Item: Jewell Addition Apartments – 1110, 1116, 1120 American Avenue

Presented By: Brad Eatherly, Planner I, Planning and Community Development

Action Requested: Approve the submitted design with conditions.

PROPOSED SITE PLAN

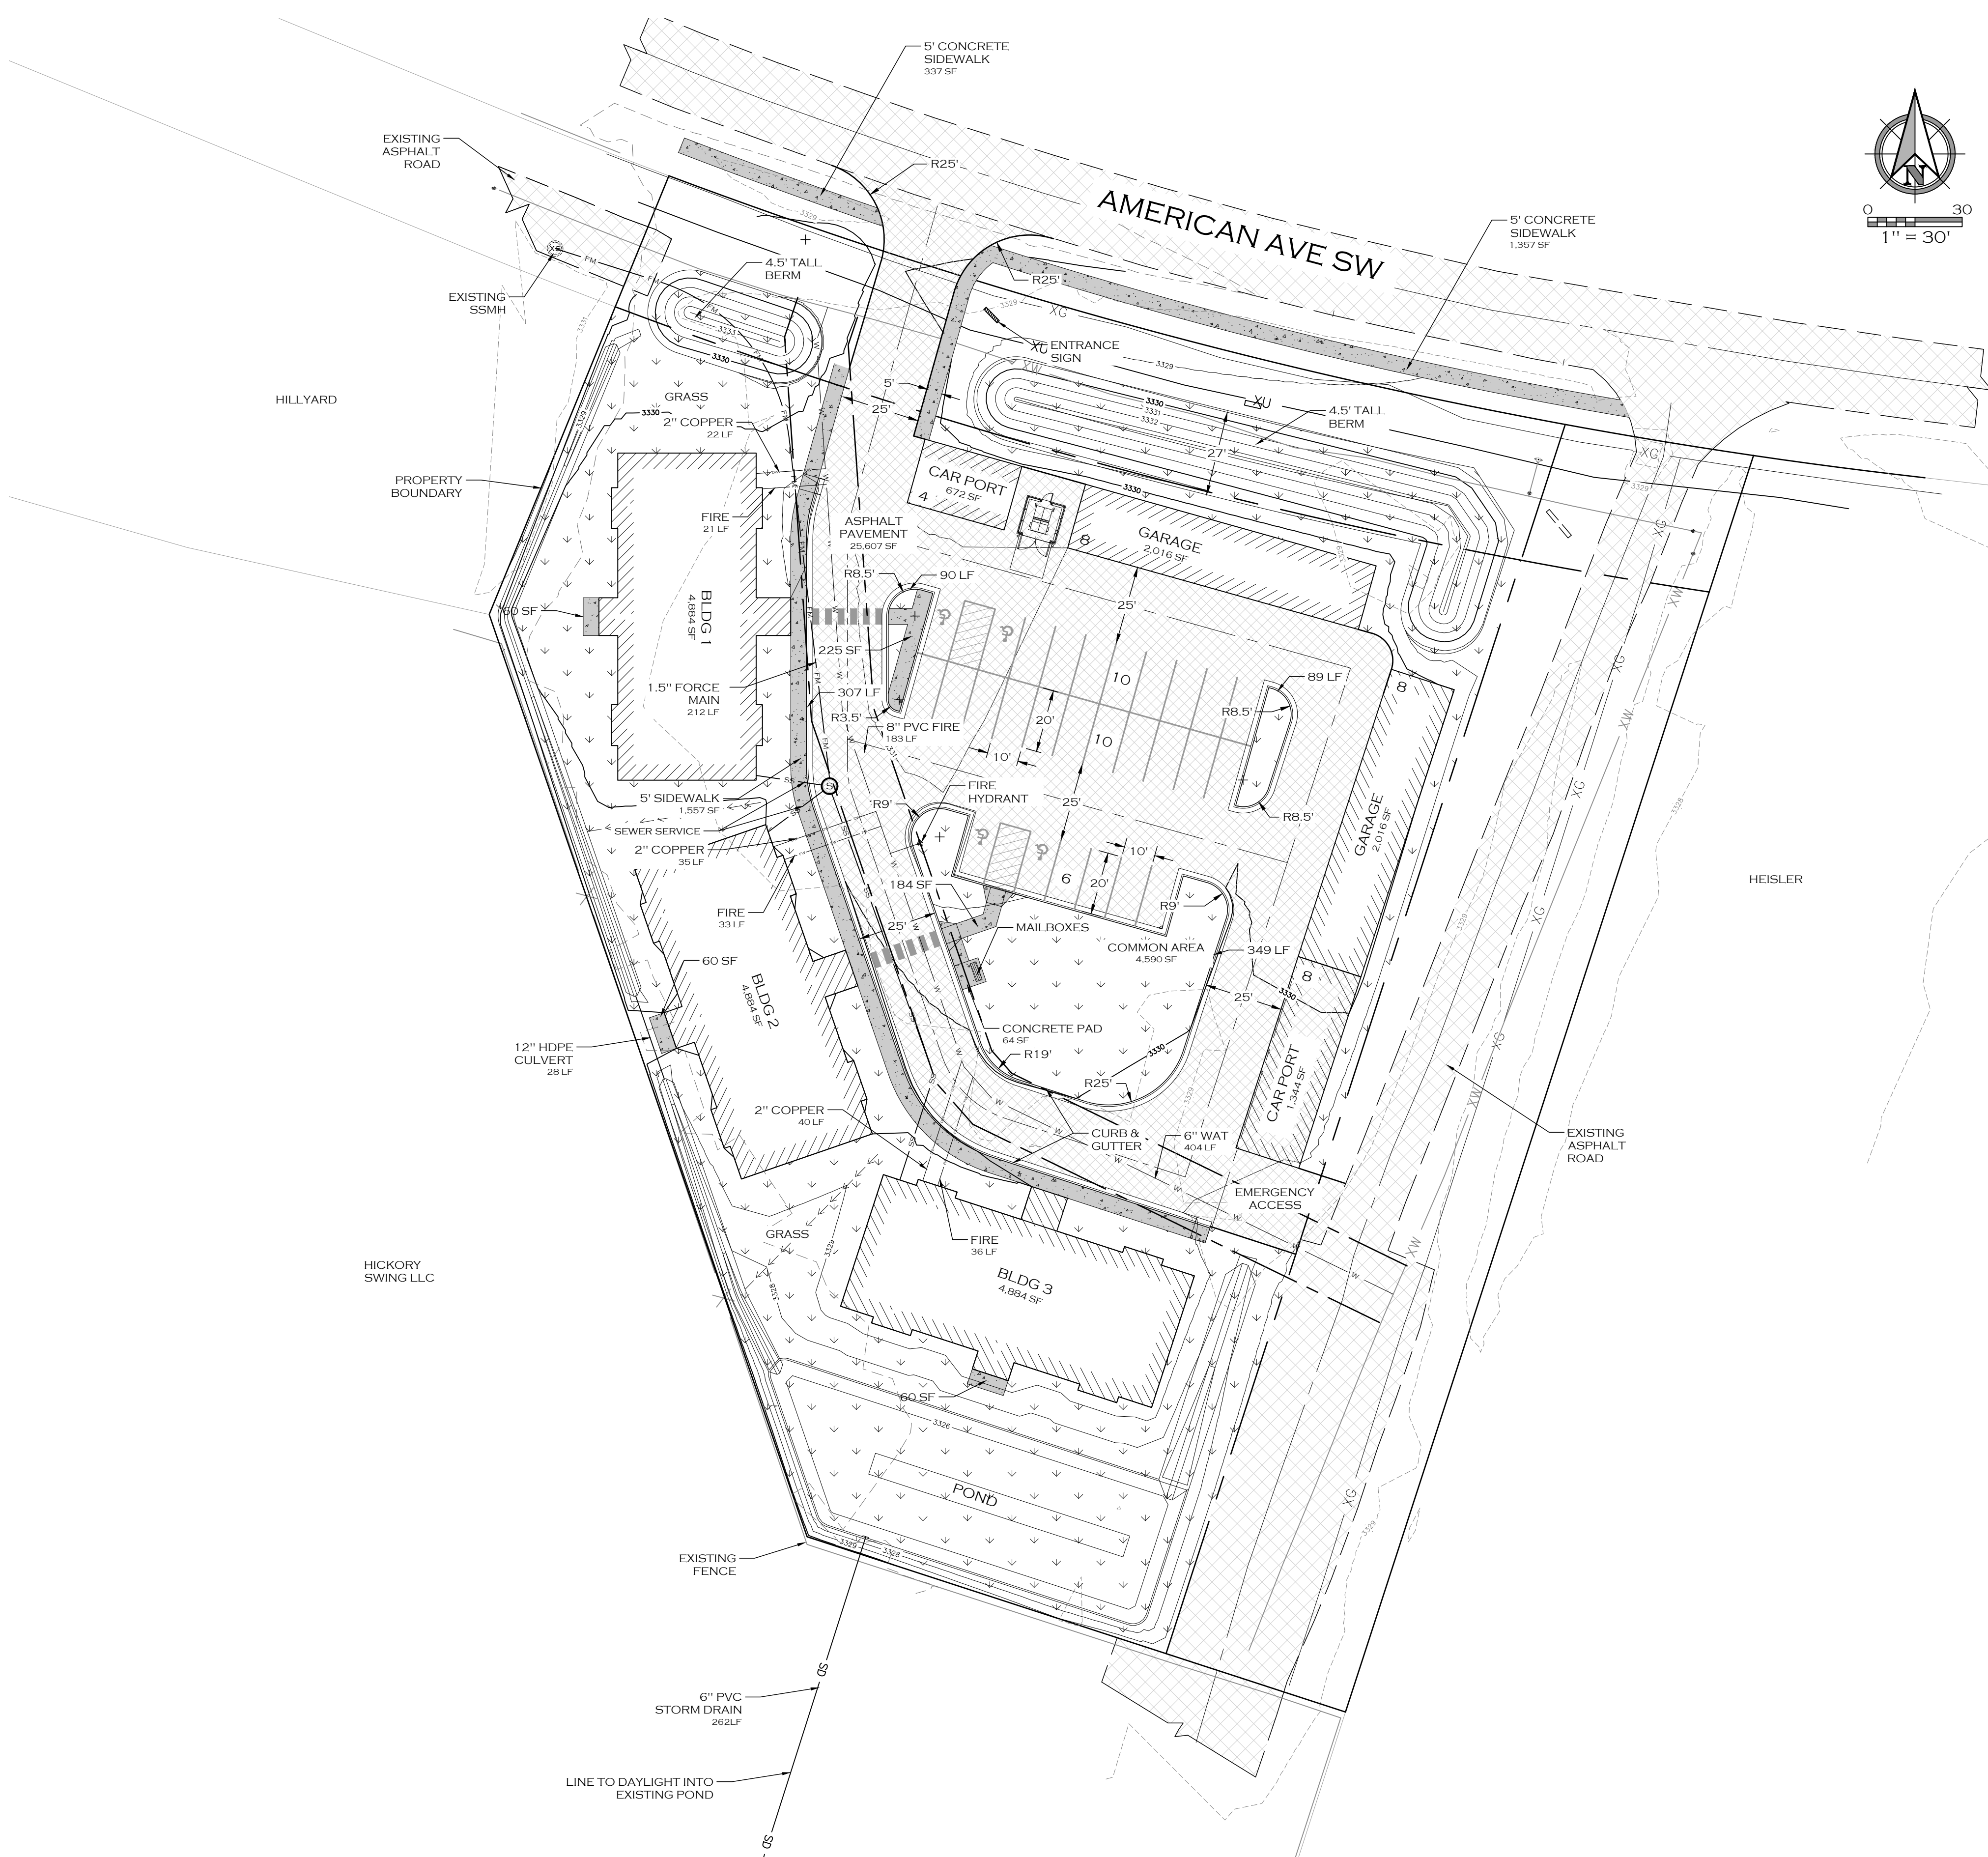
Staff believes that the configuration of the site dictates the deviation of all three guidelines. The entrance to Building 3 is located on the north of the building instead of the east, west, or south. Also, all three of the buildings do not meet Guideline #7. In regards to Guideline #11, two of the buildings, Buildings 1 and 2, do not comply with the guideline, but work well with the shape of the lot. The applicant's plan should not be required to comply with the guideline because there is a clear need to locate the buildings as far away from the railyard as possible.

The site plan includes one new curb cut off of American Avenue. Emergency access will be provided off of the drive leading to Hickory Swing Golf course. A knock-down gate is being proposed at this location to keep the property secure while also allowing access to emergency services. A looped drive within the project helps vehicular circulation while also providing access to parking spaces, carports, and garages. The proposed carports and garages also allow for residents and visitors to use the open parking spaces located in the center of the project.

Interior sidewalks are included to create safe pedestrian circulation throughout the site, and are proposed at a width of five feet. Additionally, there will be a boulevard style sidewalk with a proposed width of five feet. The OCCGF requires one and a half parking stalls per dwelling for multi-family units. The conceptual parking layout shows 56 total parking spaces, four of which will be ADA accessible. Included are 12 carport spaces and 16 garages to be utilized by the residents. This exceeds the code requirements for this particular project.

The site development will have impervious surfaces of more than 15,000 square feet; therefore, the developer is required to provide a stormwater management plan in compliance with the City of Great Falls Storm Design Manual and City standards. The plan will be reviewed and approved by the Public Works Department prior to the issuance of building permits for the development. The proposed conceptual grading plan outlines a stormwater detention area on the southern end of the parcel to provide both storage and water quality treatment. A bioswale along the west side of the site will provide additional treatment.

- A. The proposed project shall be developed consistent with the conditions in this staff report, all codes and ordinances of the City of Great Falls, the State of Montana, and all other applicable regulatory agencies.

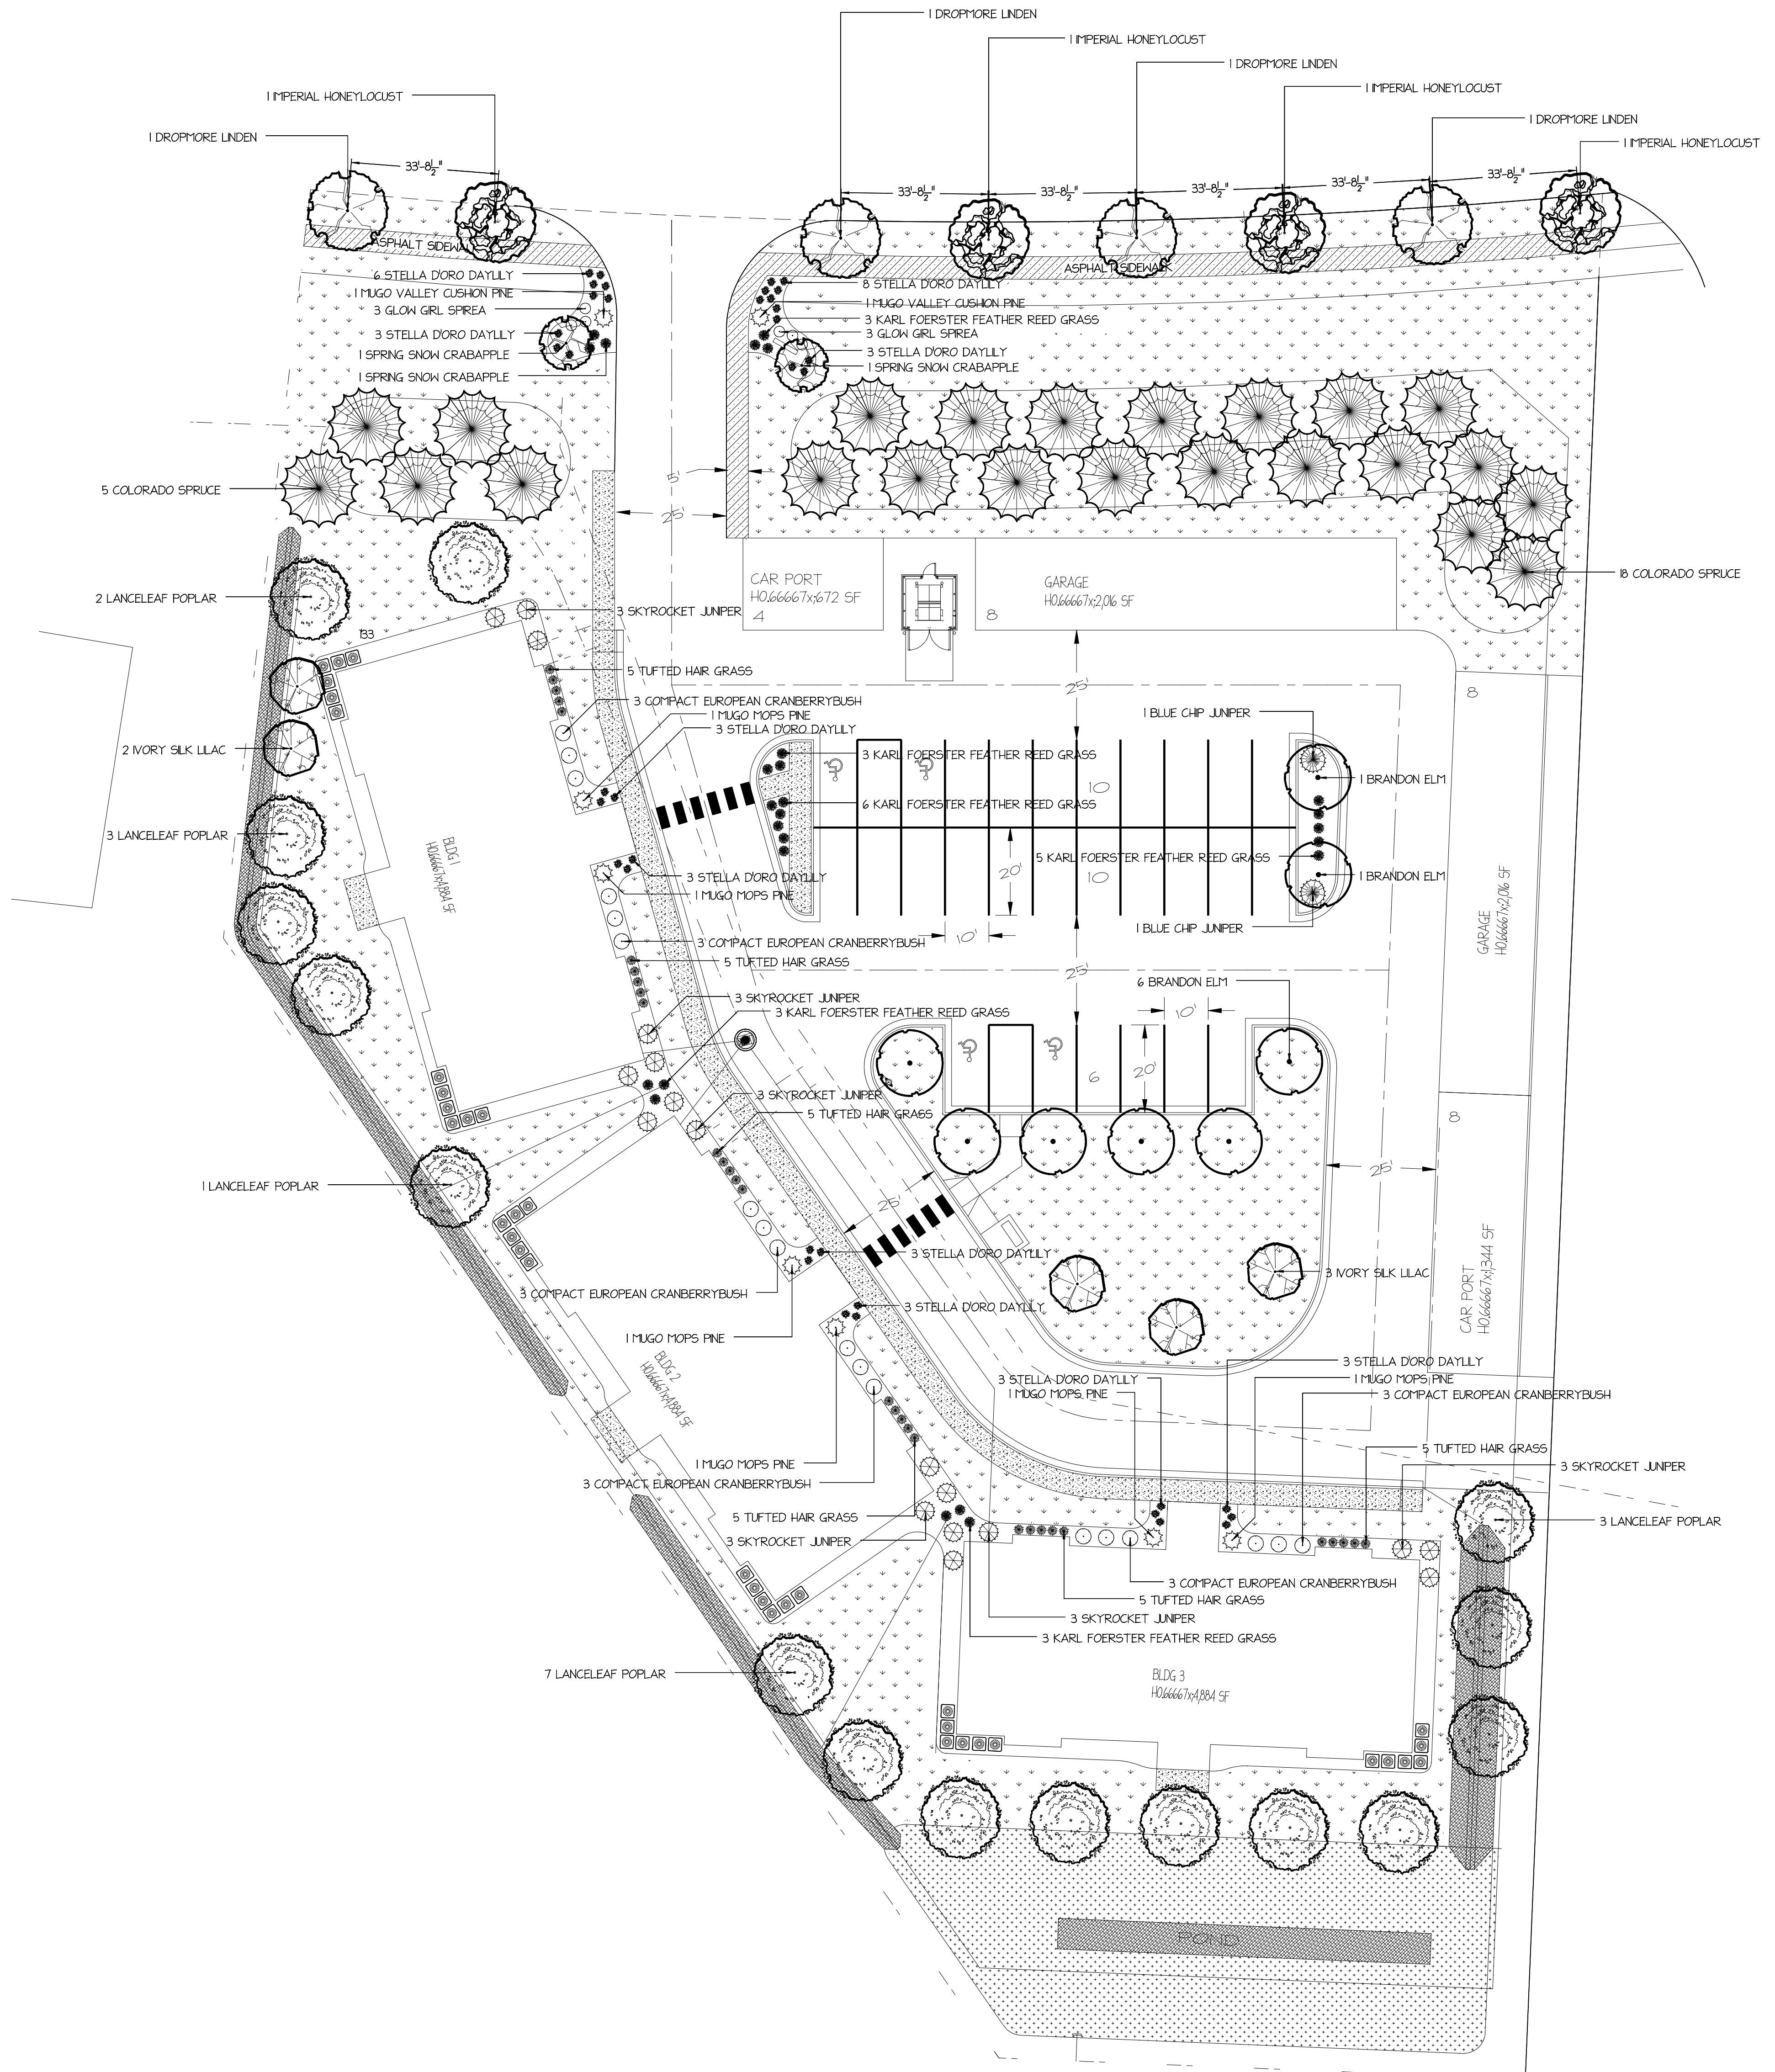
The proposed landscaping is in compliance with the minimum requirements of the OCCGF. The OCCGF requires one (1) tree per 1,500 square feet of net lot area and at least 50% of the net lot area to be landscaped with turf grass or ground cover plants. The exterior of the site will be significantly improved by landscaping including grass, canopy trees, shrubs, and perennials. According to Chapter 44 – Landscaping of the OCCGF, 53 interior trees and eight (8) boulevard trees are required to be installed. The applicant is proposing 54 interior trees in addition to proposing 143 shrubs and perennials for the site. The applicant's proposal is in compliance with code requirements.
